Well Name: WF FEDERAL 25	Well Location: T30N / R14W / SEC 25 / SESE / 36.779918 / -108.256794	County or Parish/State: SAN JUAN / NM
Well Number: 2	Type of Well: CONVENTIONAL GAS WELL	Allottee or Tribe Name:
Lease Number: NMNM0207001	Unit or CA Name:	Unit or CA Number:
US Well Number: 3004530713	Well Status: Abandoned	Operator: HILCORP ENERGY COMPANY

Subsequent Report

WF FEDERAL 25 2
30-045-30713
NMNM0207001
SR P&A

Well Name: WF FEDERAL 25 #2

Current Schematic - Version 3

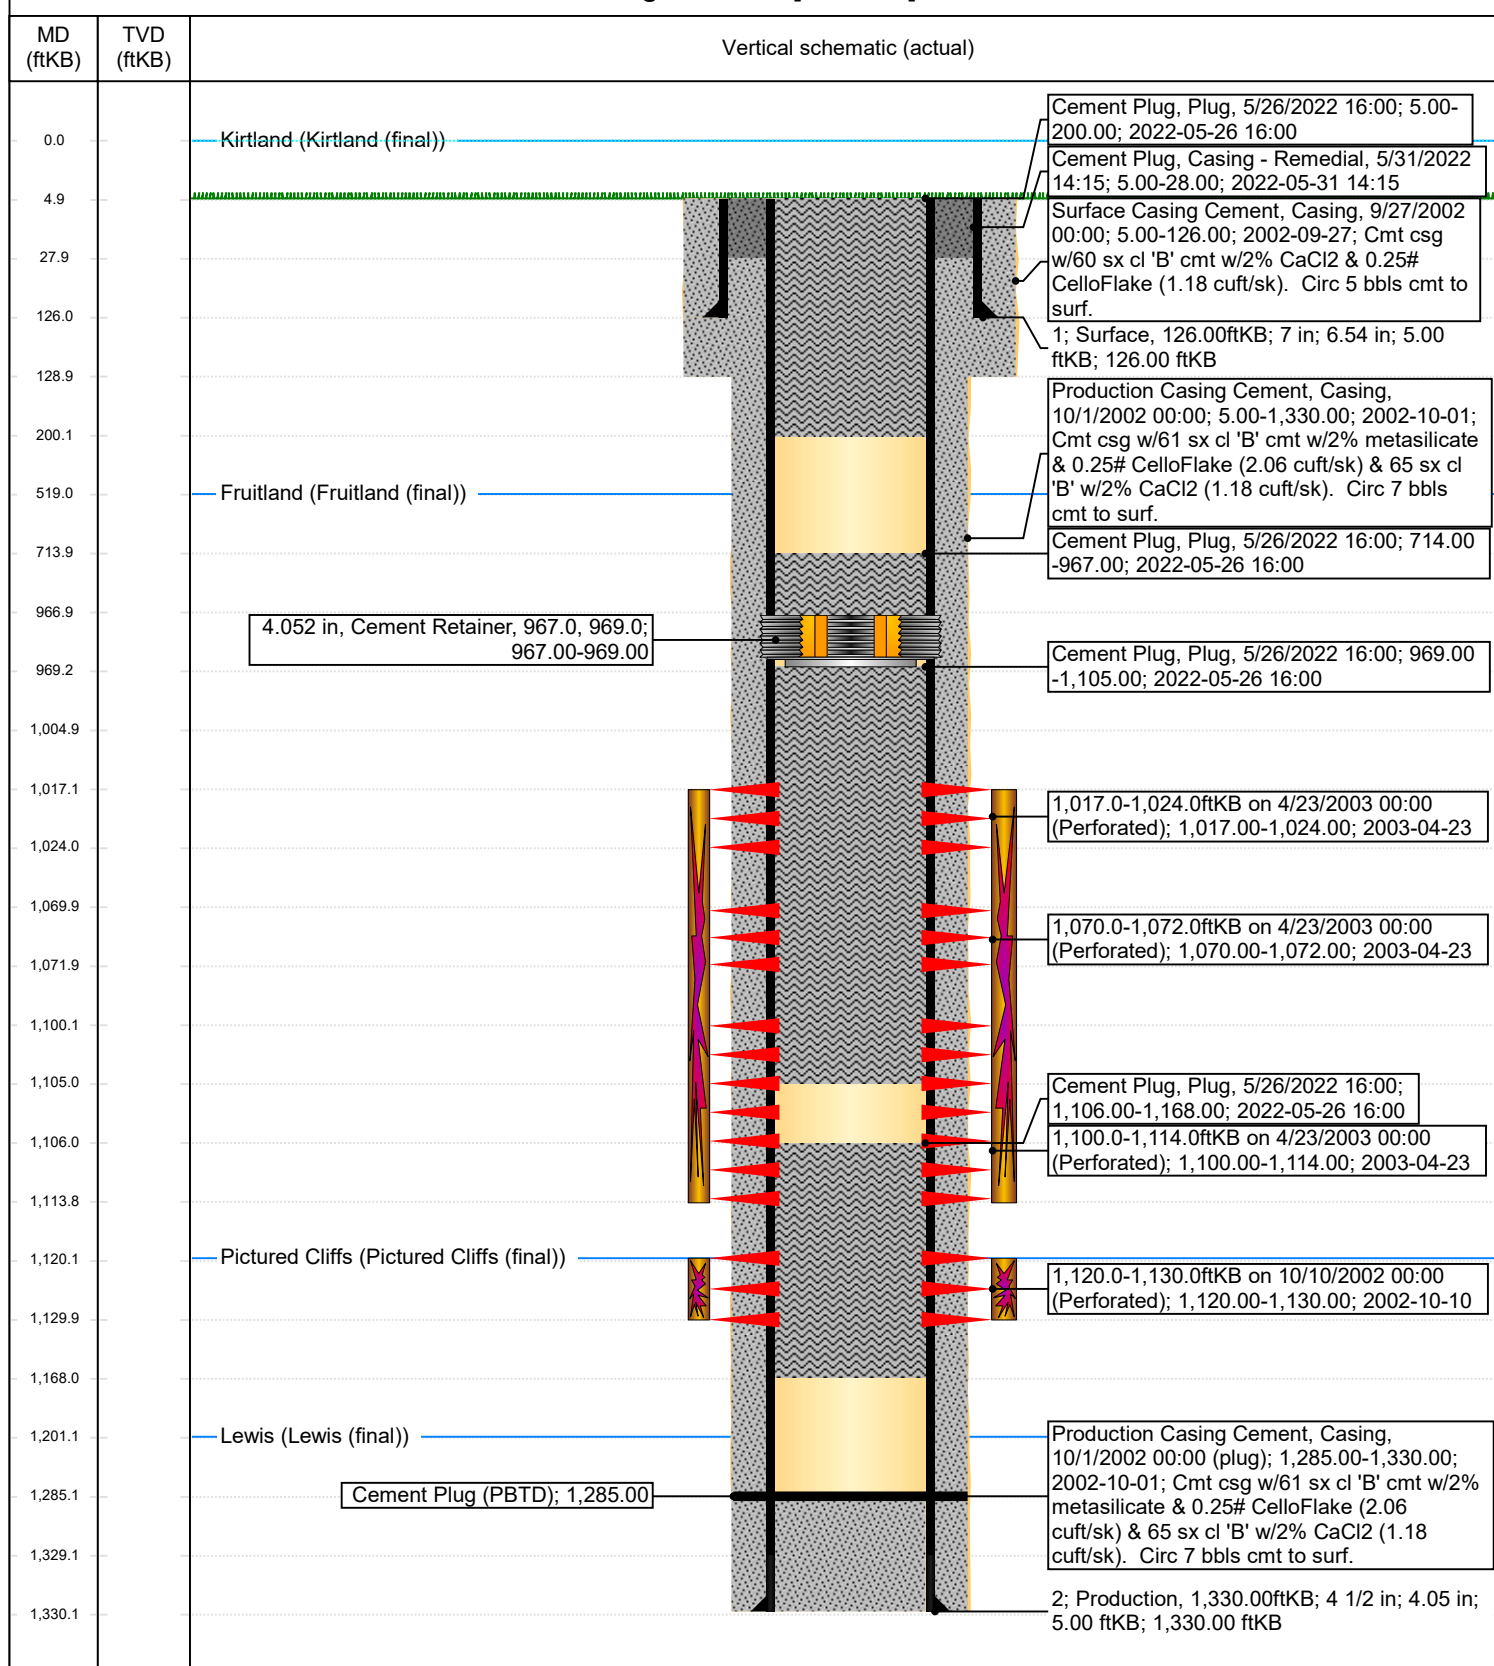
Created By	Condition	Condition Date
mkuehling	schematic shows fruitland coal at 519 and blm called it at 814 - the plug is good however the schematic is off.	6/23/2022
